PERMIT

P 44087
A REPAIR

SEWAGE DISPOSAL SYSTEM

HOWARD COUNTY
BUREAU OF ENVIRONMENTAL HEALTH
461-9933

P44087

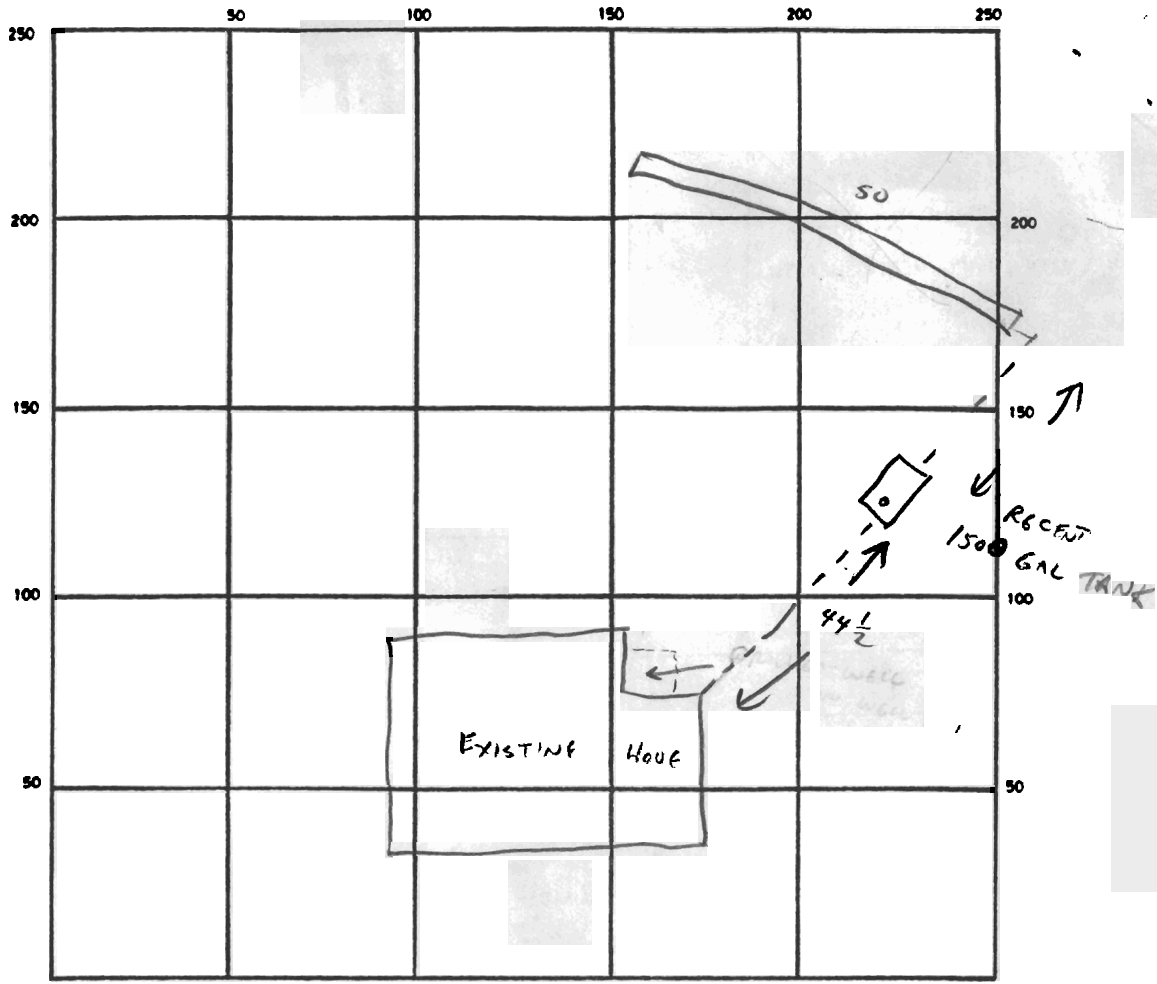
REMARKS 4/24/88 TANK AND EXISTING 50' TRENCH RECENTLY INSTALLED
CONCRETE PIPE, NO PAPER GUN TRENCH
NOT PERMITTED, LIKELY SHALLOW TRENCH INLET 3' BELOW GRADE, 3' WIDE
SOILS JUDGED ADEQUATE FOR SOME TYPE OF SYSTEM, ADDITIONAL CAPACITY REQUIRED
FOR 4 BR. HOUSE. OK TO ISSUE BP AFTER REVISED DETAILS TO WELL DIMENSIONS
OF TRENCH TO BE DETERMINED AT TIME OF INSTALLATION.
